2ND INSTALLMENT

THE VILLAGE ON THE PARKWAY

PAVING & GRADING
IMPROVEMENTS
WATER, SANITARY SEWER & STORM SEWER
IMPROVEMENTS

ALBERT H. HALFF ASSOCIATES, INC.-ENGINEERS
DALLAS, TEXAS
FEB. - 1979
A.V.O. 6143Z

HORIZONTAL LAYOUT & PAVING PLAN
VILLAGE ON THE PARKWAY
VILLAGE PARKWAY VENTURE
Albert H. Wolff Associates, Inc. - Engineers
CITY OF ADDISON, TEXAS

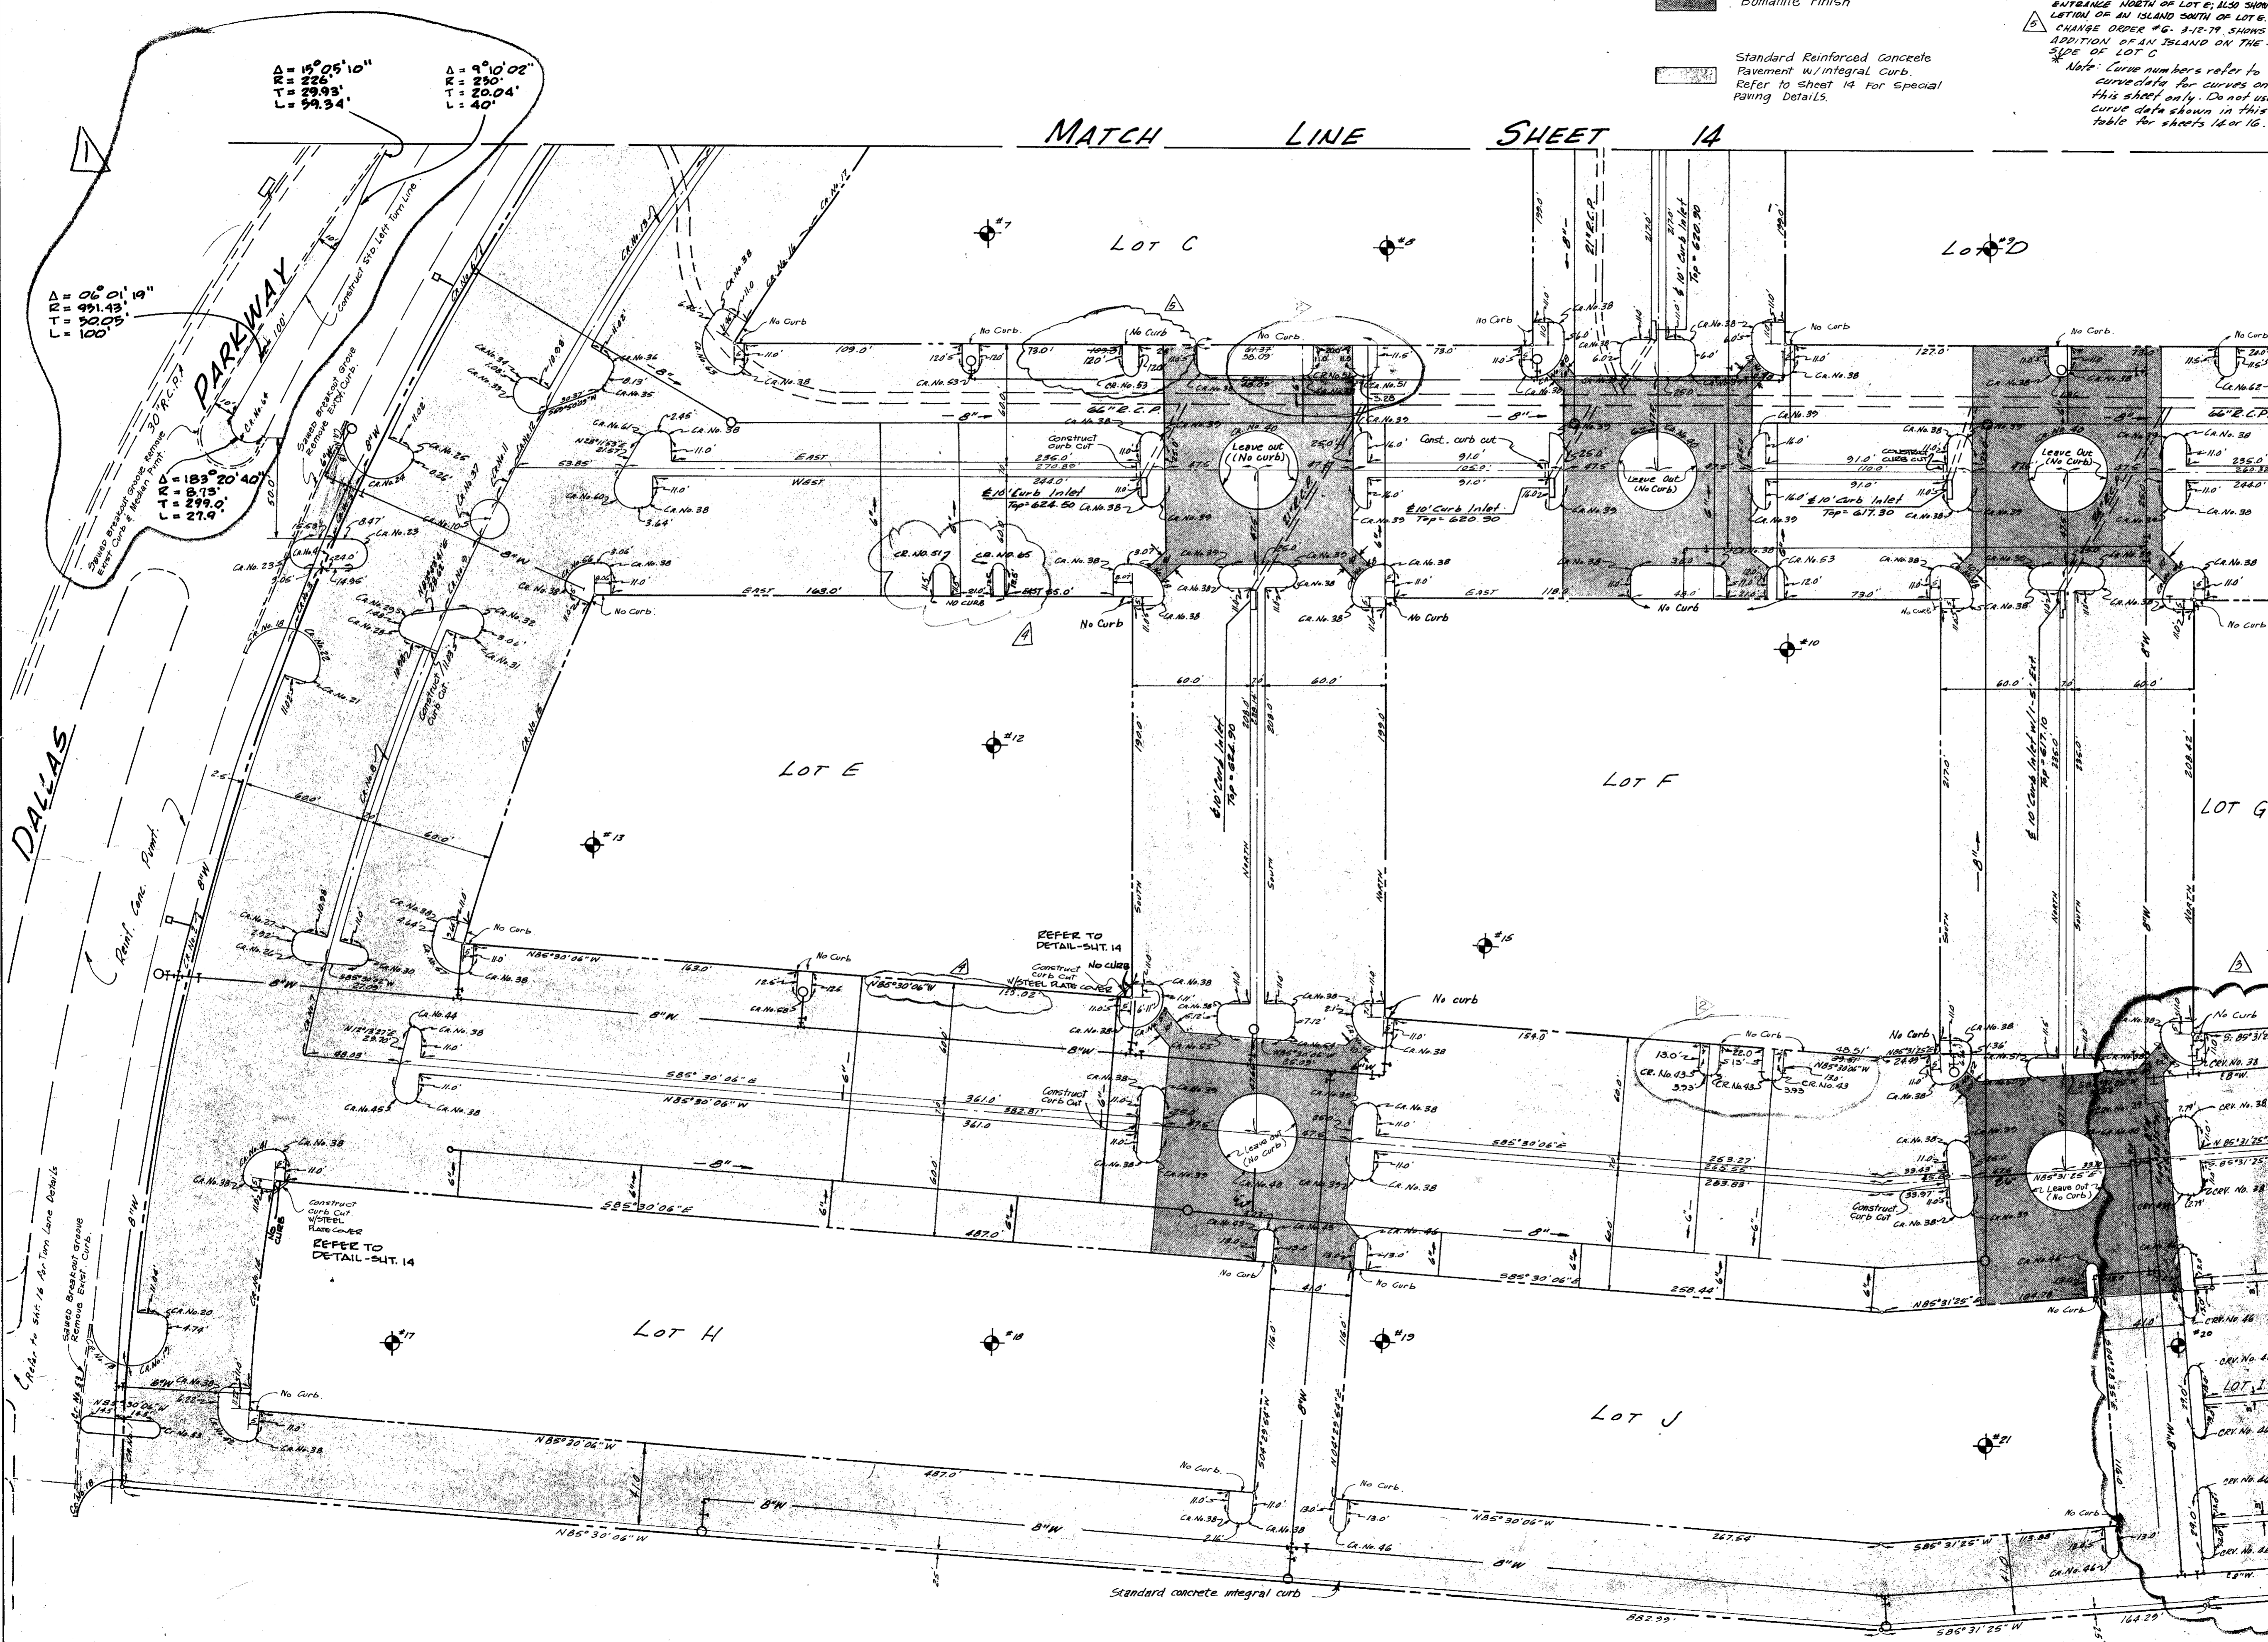
CHANGE ORDER #5 2-16-79 SHOWS REVISED
ENTRANCE NORTH OF LOT E; ALSO SHOWS DE-
LETION OF AN ISLAND SOUTH OF LOT E.

CHANGE ORDER #6 3-12-79 SHOWS THE
ADDITION OF AN ISLAND ON THE SOUTH
SIDE OF LOT C

10/20/78 REVISED SERVICE DRIVE DIMENSIONS SOUTH SIDE OF C.P.

DRAINAGE AREA MAP						
VILLAGE ON THE PARKWAY						
VILLAGE PARKWAY VENTURE						
ALBERT H. HALFF ASSOCIATES, INC.						
CITY OF ADDISON, TEXAS						
DESIGN	DRAWN	DATE	SCALE	NOTES	FILE	No.
AHH	MBM	MAY 1978	1"=100'	643

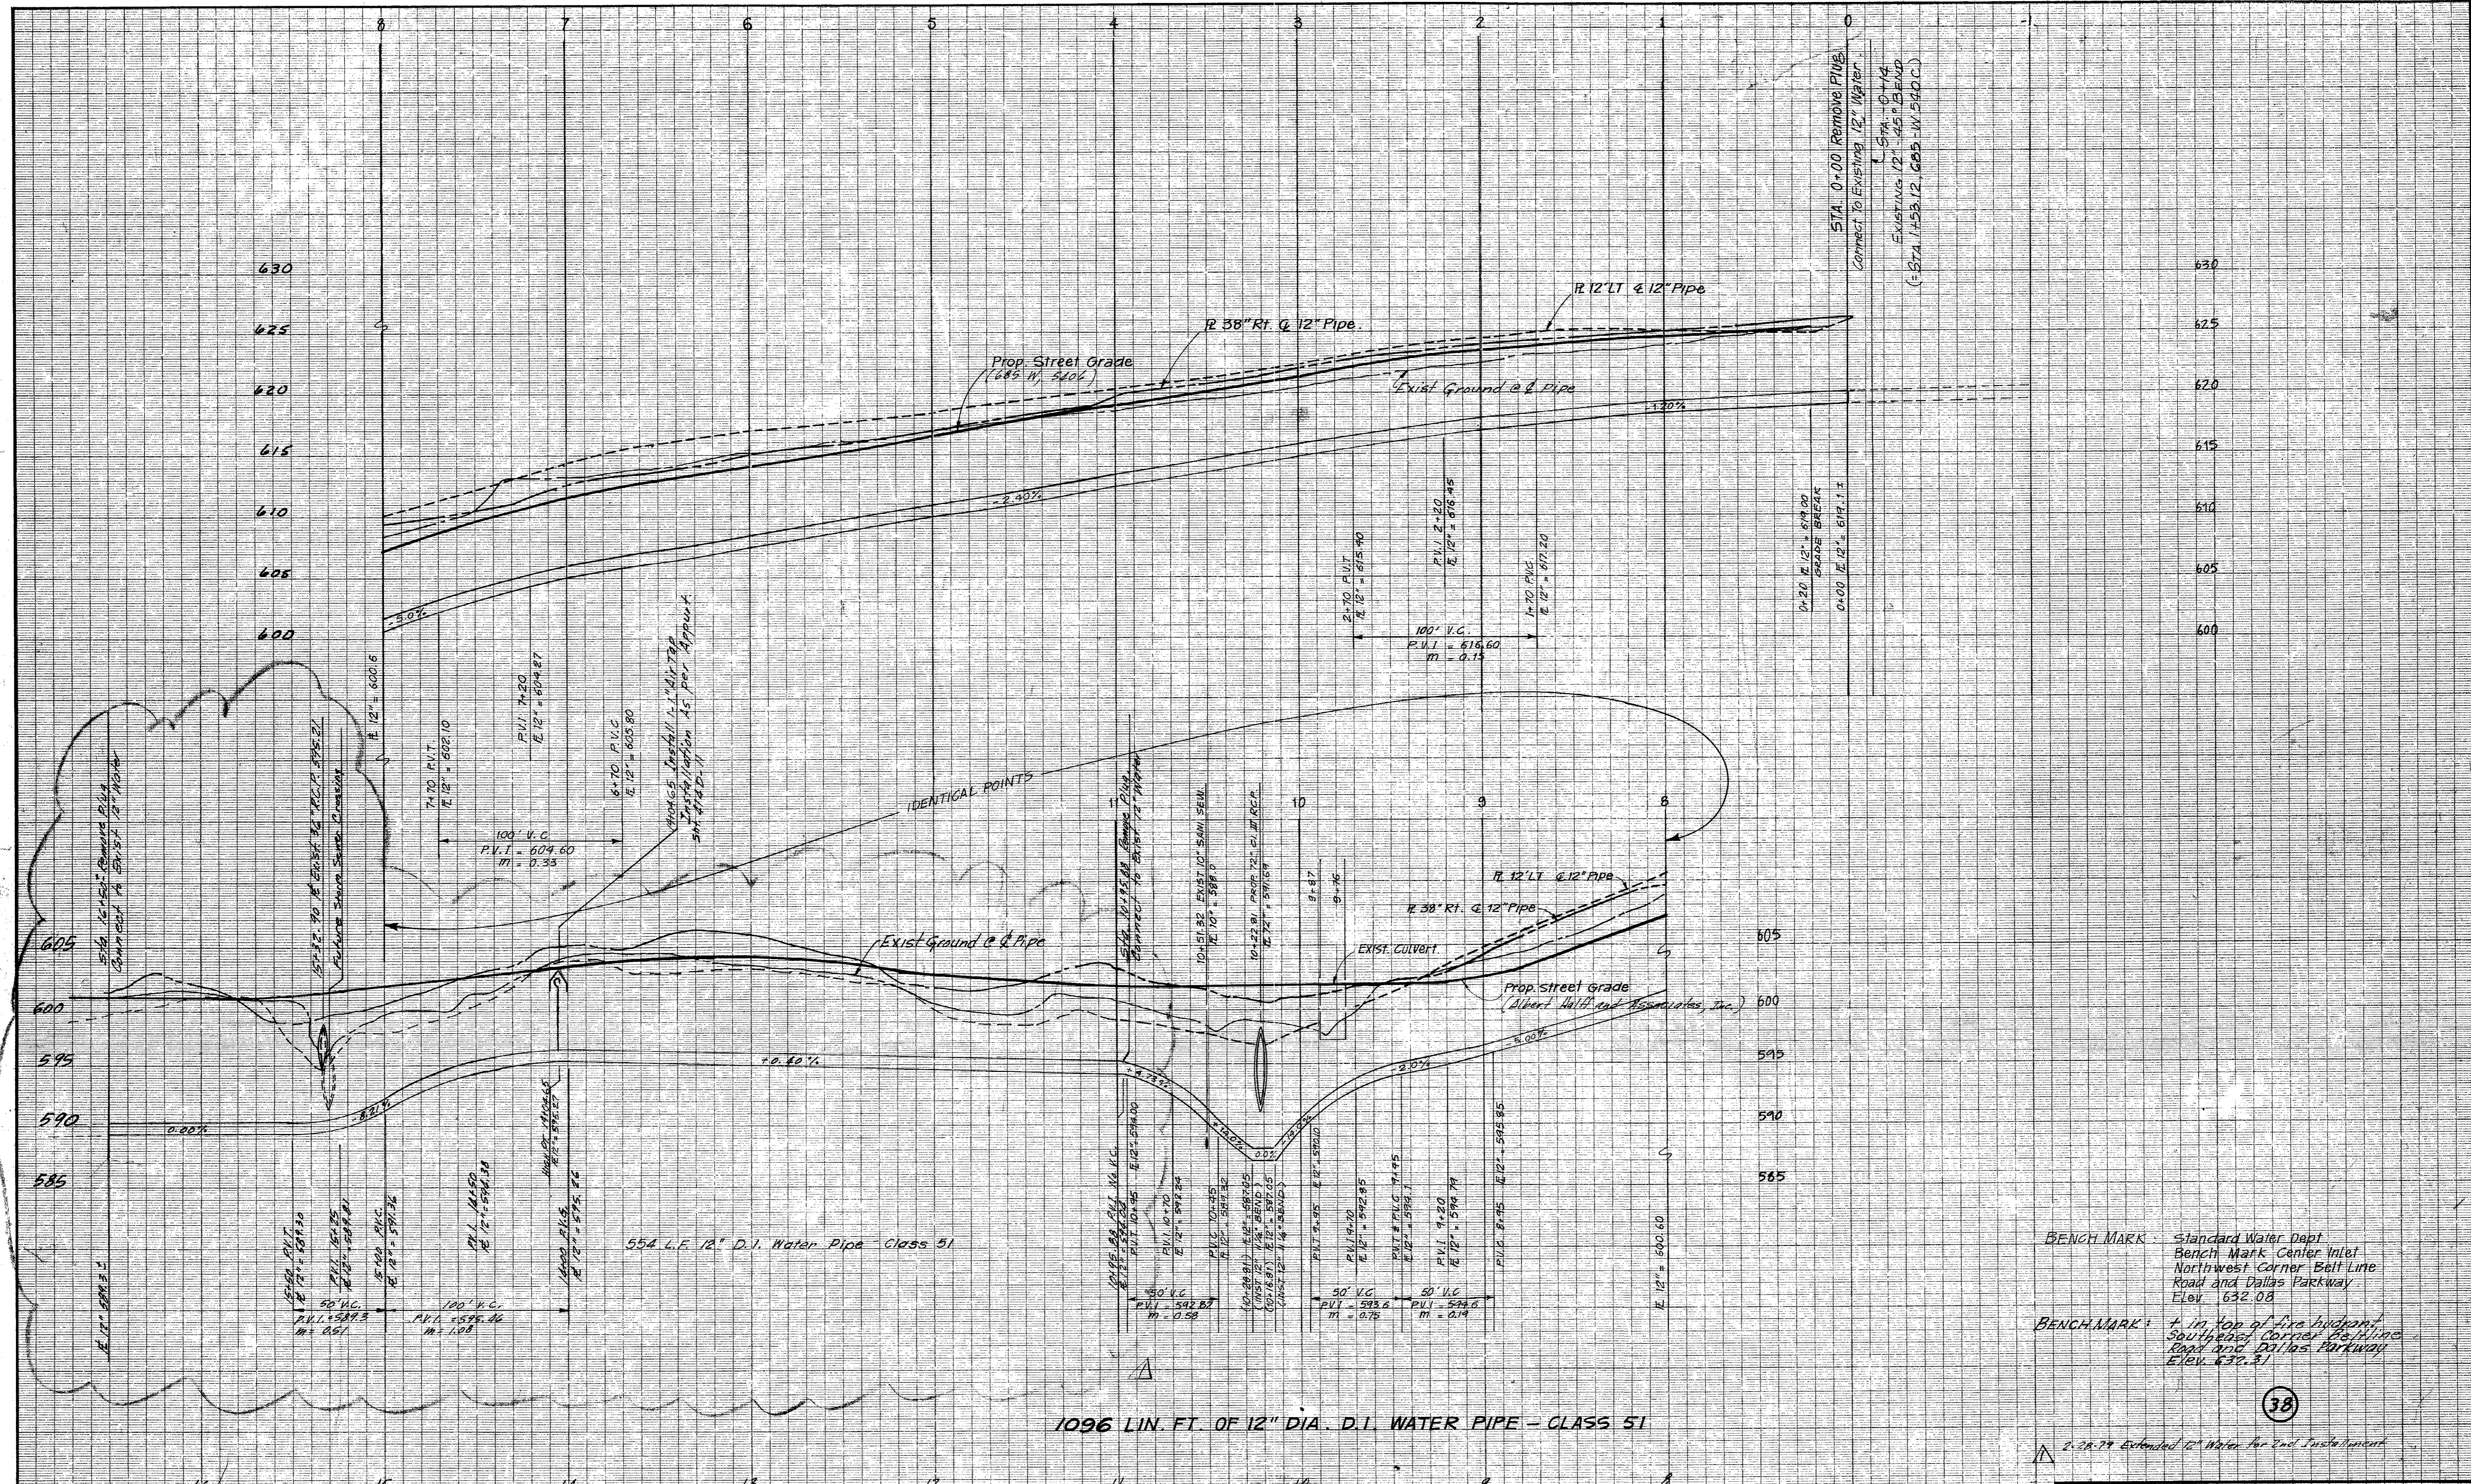
2/20/79 REVISED DRAINAGE AREAS AS PER 2ND INSTALLMENT GRADING PLAN

HORIZONTAL LAYOUT & PAVING PLAN
VILLAGE ON THE PARKWAY
VILLAGE PARKWAY VENTURE
Albert H. Holth Associates, Inc. - Engineers
CITY OF ADDISON, TEXAS

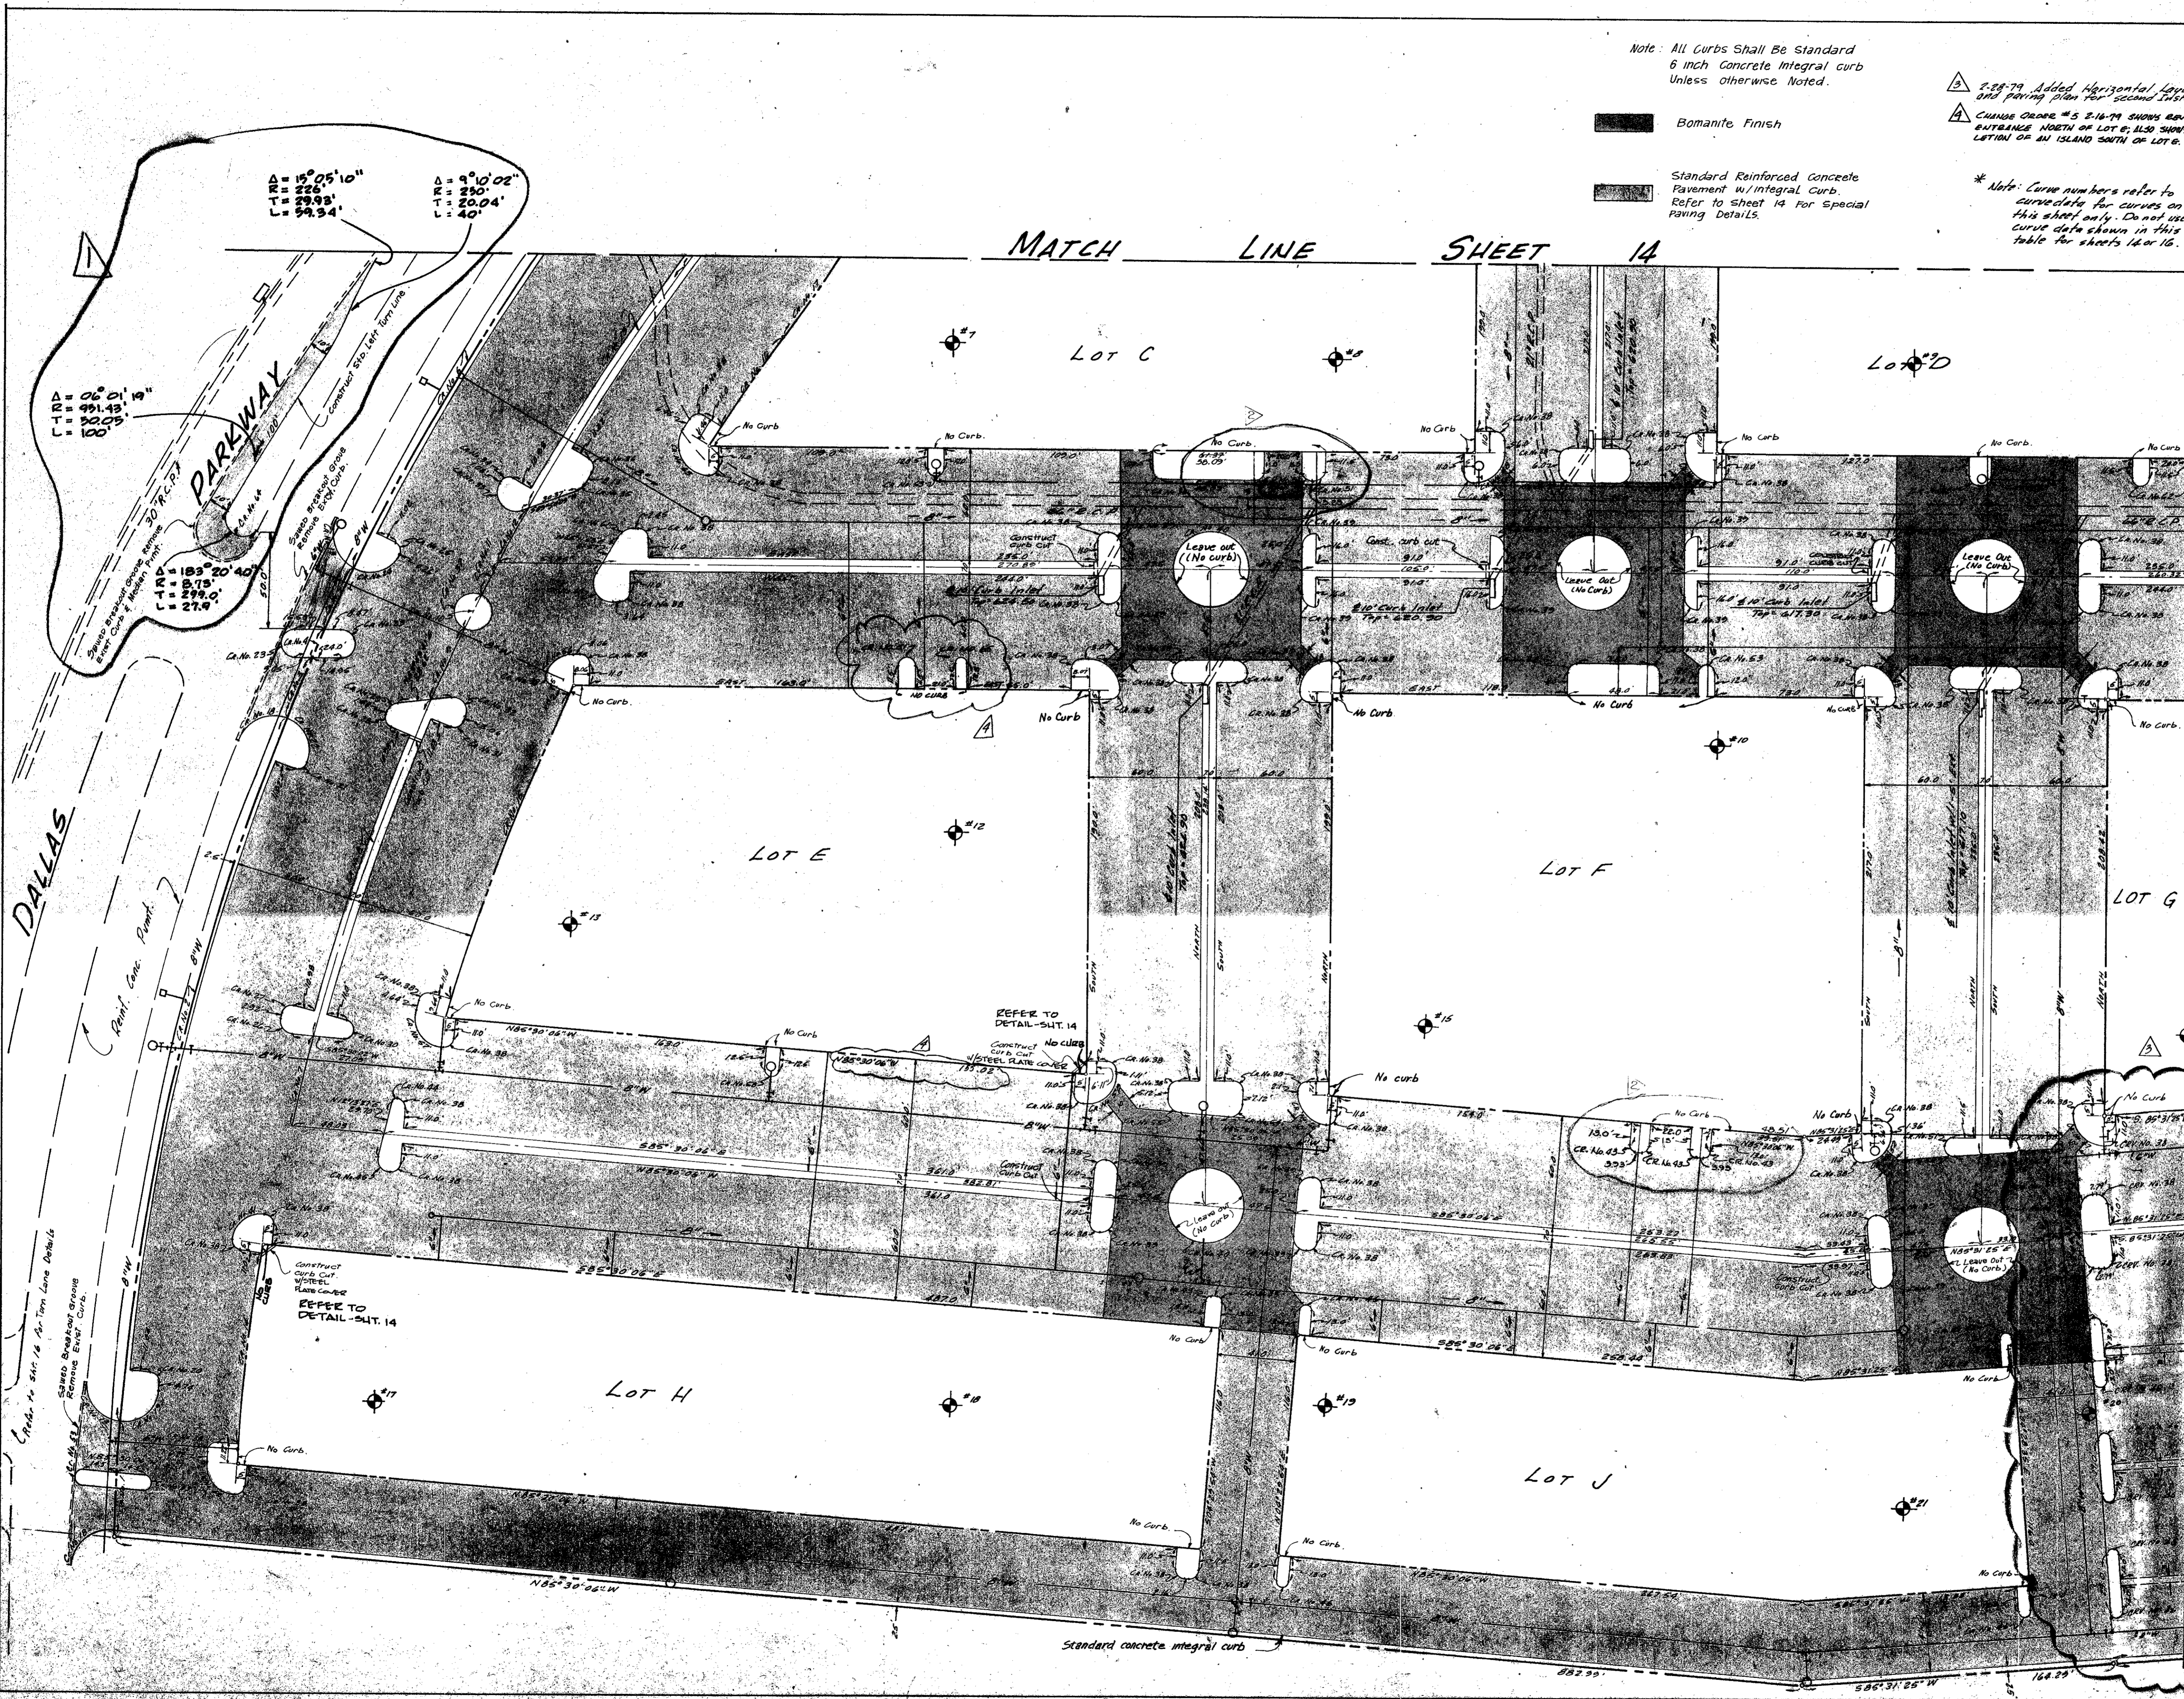
△ 2-28-79 Added Horizontal Layout
and paving plan for second installation
△ CHANGE ORDER #5 2-14-79 SHOWS REVISED
ENTRANCES NORTH OF LOT E; ALSO SHOWS DE-
LETION OF AN ISLAND SOUTH OF LOT E.

△ 10/30/78 REVISED SERVICE DRIVE DIMENSIONS SOUTH SIDE OF C&F
